**BOROUGH OF HIGHLANDS**  
**LAND USE BOARD MEETING**  
22 Snug Harbor Avenue, Highlands NJ 07732  
Thursday, March 10, 2022 at 7:00 PM

**AGENDA**

REV	DATE	DESCRIPTION	BY	CHECK			
MINOR SUBDIVISION PLAN FOR <b>THOMAS FAHEY</b> LOT 6 BLOCK 14 SHEET 6 BOROUGH OF HIGHLANDS, MONMOUTH COUNTY, NEW JERSEY RICHARD E. STOCKTON & ASSOC., INC. SURVEYING & MAPPING->PLANNING->CONSTRUCTION SURVEYING PO BOX 124, ATLANTIC HIGHLANDS, NJ 07716, 732-872-2827							
RICHARD STOCKTON, LICENSED PROFESSIONAL LAND SURVEYOR & PLANNER PLS15102 PP2267							
DATE:	9-30-21	FILE:	4276	DRAWN:	RLT	JOB NO:	8158
SCALE:	1" = 20'	CAD#:	P-8158sub1.dwg	CHECKED:	Res	DWG NO:	D-1047

**Re: Farrell Residence  
 32 Shrewsbury Avenue  
 Block 43, Lot 7  
 Waterfront Transition-Residential (WT-R) Zone  
 Minor Site Plan with variances  
 First Engineering Review**

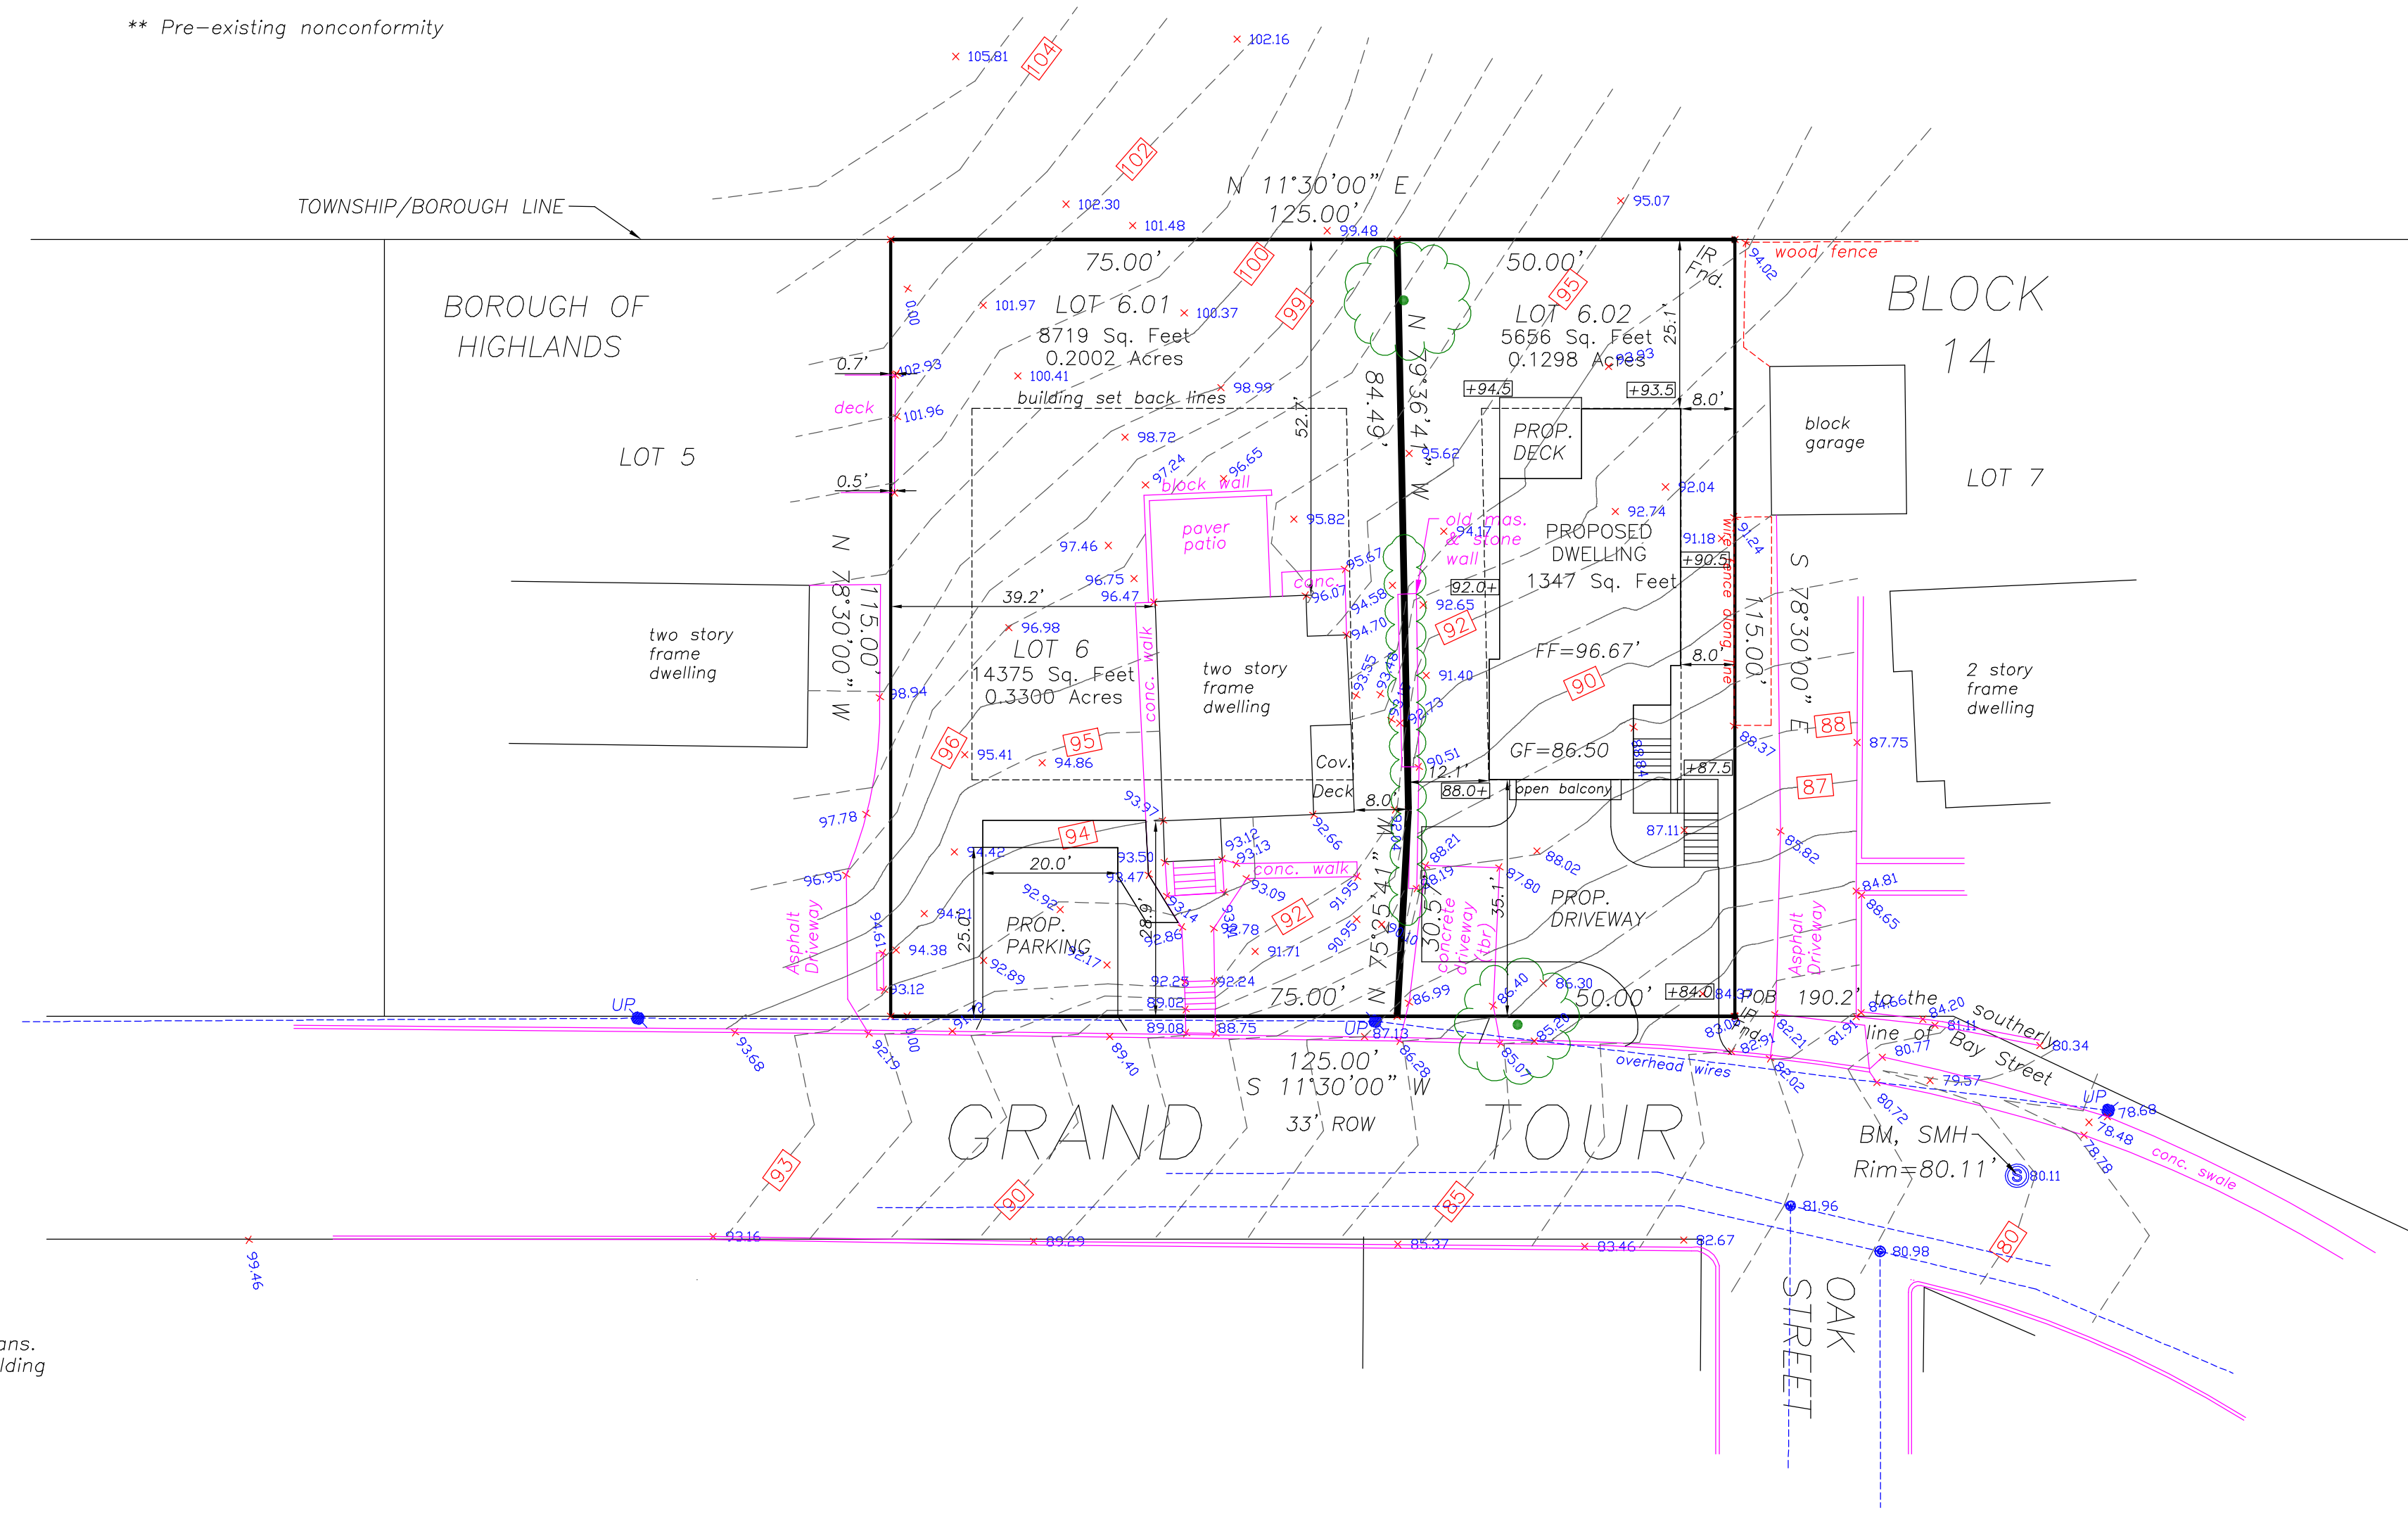
1. The applicant shall provide testimony on the rear deck of Proposed Lot 6.02 and whether it is elevated or at ground level. This may affect the rear setback requirements if this is considered part of the principal structure.

4. While the project is not considered a major development, the applicant is proposing to increase impervious coverage by approximately 3,115 square feet. The applicant shall provide testimony on the stormwater management measures provided and how the increase from pre- to post-development stormwater runoff will not have a negative impact on the site and downstream off-site stability affected by stormwater runoff.

5. The applicant has graded the property to follow the existing drainage patterns and drain towards the existing roadways. The applicant shall provide testimony on any adverse drainage impacts to the adjacent properties as a result of the proposed improvements.

6. The applicant shall provide testimony regarding the suitability of existing utility connections and/or additional utility connections or improvements necessitated by the subject application. All proposed utility improvements shall be shown on the plans including proper trench restoration.

7. A note shall be added to the plans indicating that all utilities are to be installed underground.
8. The applicant shall also be aware that a sanitary sewer connection fee must be paid prior to issuance of building permits.

- a. Section 46:26.B-2.b.8 of the Map Filing Law requires a minimum of three corners distributed around the tract shall indicate coordinate values. This coordinate base needs to be either assumed or based on the New Jersey Plane Coordinate System and shown on the map.

- c. A listing of owners within 200' shall be provided on the map.
  - d. All appropriate certifications as deemed necessary in Section 46:26.B-2.b of the Map Filing Law including but not limited to surveyor preparing the map, surveyor who prepared the boundary survey, municipal clerk, Planning Board, owner, and applicant, with appropriate titles, shall be provided on the plan.
